RECEIPT DATE: 6-3-19 **ONSITE SEWAGE DISPOSAL SYSTEM**

PROPERTY ADDRESS: 15204 Torino Way

SUBDIVISION: Fairlane Farms

**RE: OSDS Plan**  
**15204 Torino Way**

AS BUILT RECOVERED FROM  
IN FIELD MEASUREMENTS  
AUG 2019. (P)

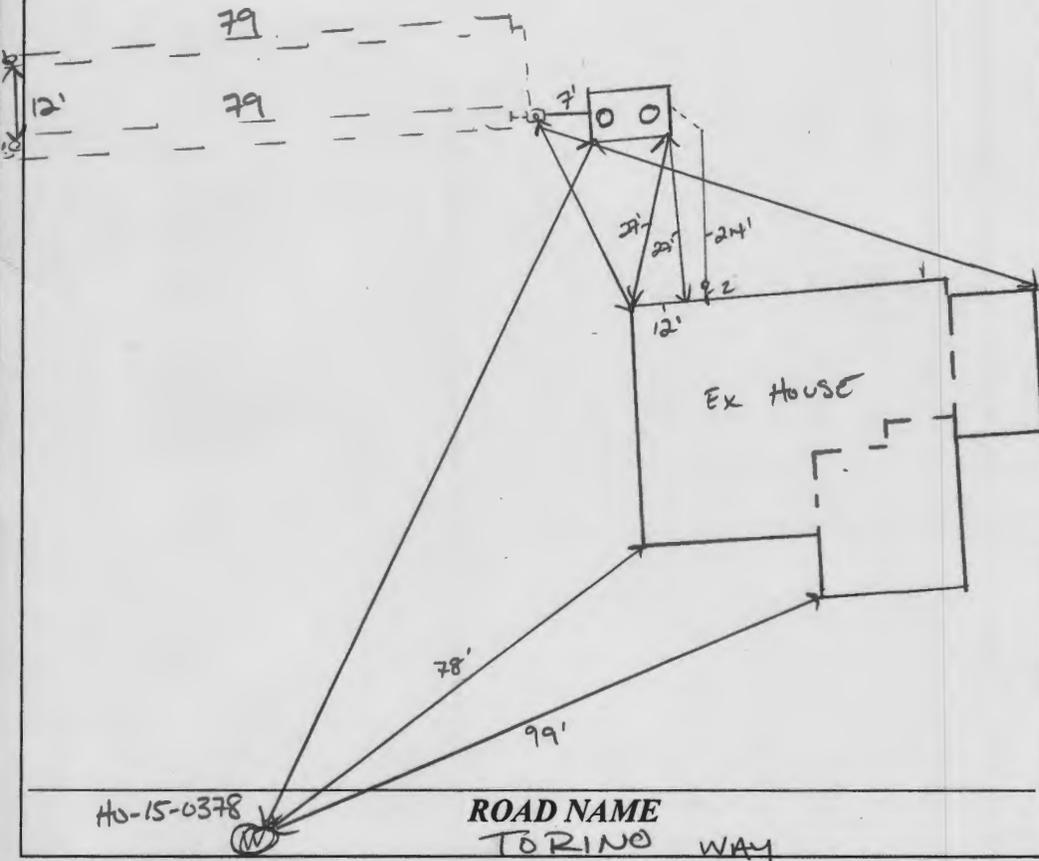
6/27/2019 TANK AND SDA STAKED. SEWER OUT OF HOUSE SHIFED TOWARDS WELL. FALL OK BACK TO TANK LOCATION 2x 79' TRENCHES ON CONTOUR. (P)

INSTALLATION: 07/2019 TRENCHES COMPLETED. TANK TO BE RELOCATED. MUST REVISE OSDS AND PERC CERT TO INSTALL TANK IN PROPOSED LOCATION WITHIN WELL BOX PER APPROVED PC (P) 7/16/2019 REVISED PC SIGNED. (P) 7/26/2019 TANK SET, SHC INSTALLED, D BOX LEVELED WITH SPEED LEVELS. OK TO BACKFILL (P)

**SEPTIC SYSTEM INSTALLATION SITE PLAN**

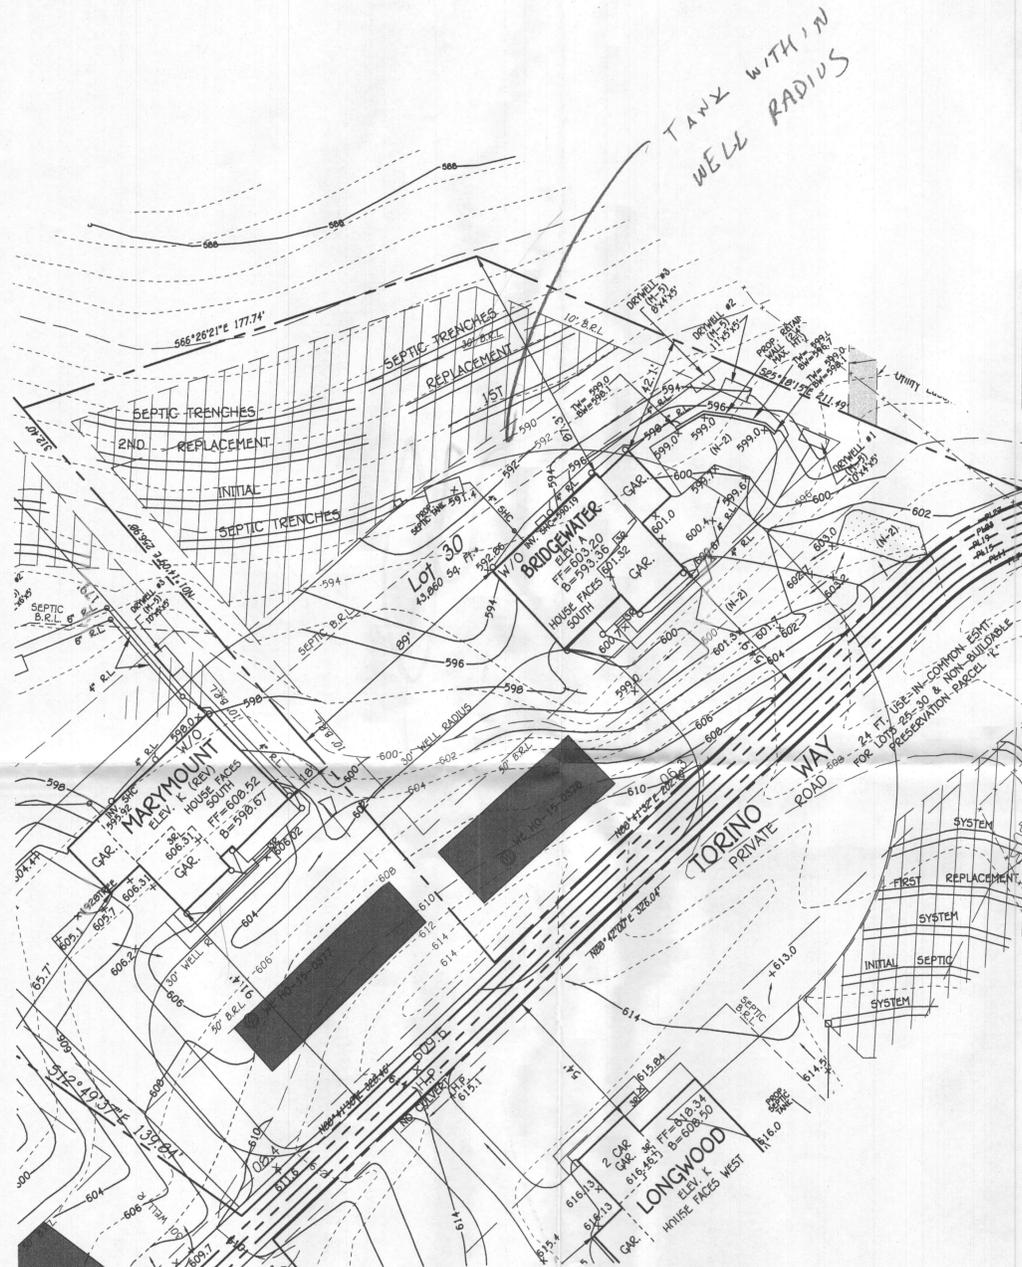
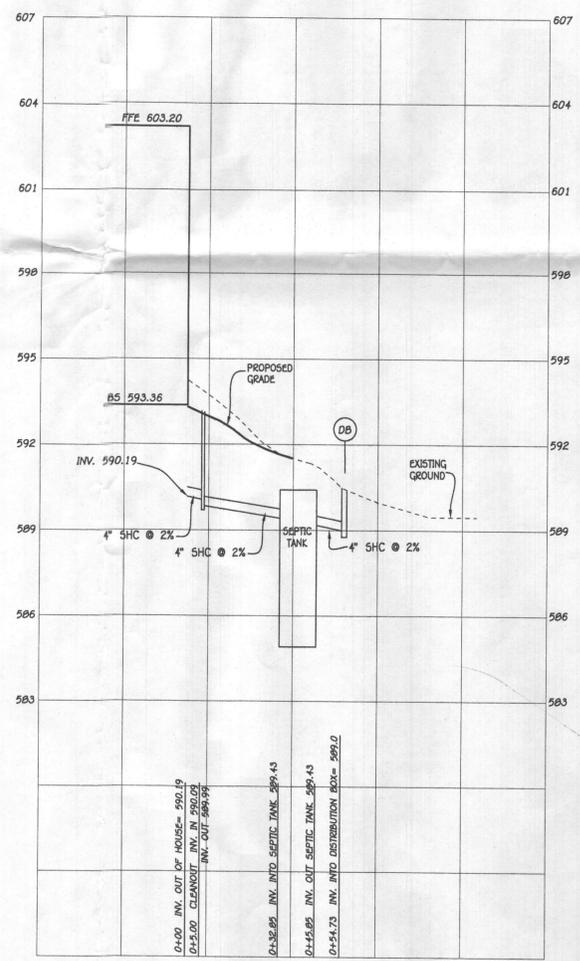
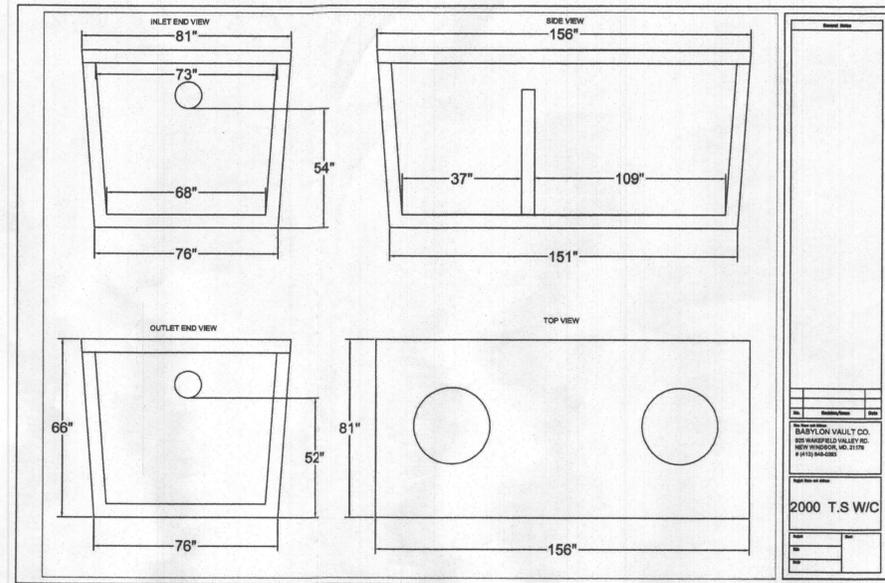
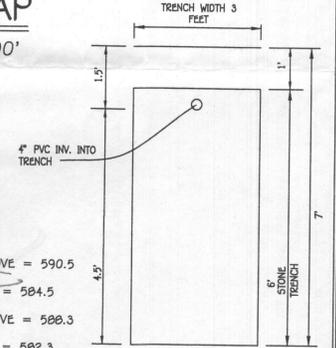
The OSDS Plan shows 3-65.1 foot trenches for 1<sup>st</sup> replacement system in layout but the calculation states 2-97.66 to be installed. Ok to redline calculation?

Floor plan shows unfinished basement with full bath with a potential for an additional bedroom upon finishing it. Health recommends sizing the septic system for 6 bedrooms.

The OSDS Plan for 15204 Torino Way is still showing a sidewall credit of 3 feet for the 2<sup>nd</sup> replacement system. It should be 2 feet. It's a difference of  $195.31 - 156.25 = 39.06$  feet

- 1.) Sidewall credit for 2<sup>nd</sup> replacement system should be 2 not 3 feet.
- 2.) Invert out of d-box conflicts with invert into initial trench.
- 3.) Septic tank is within well radius.
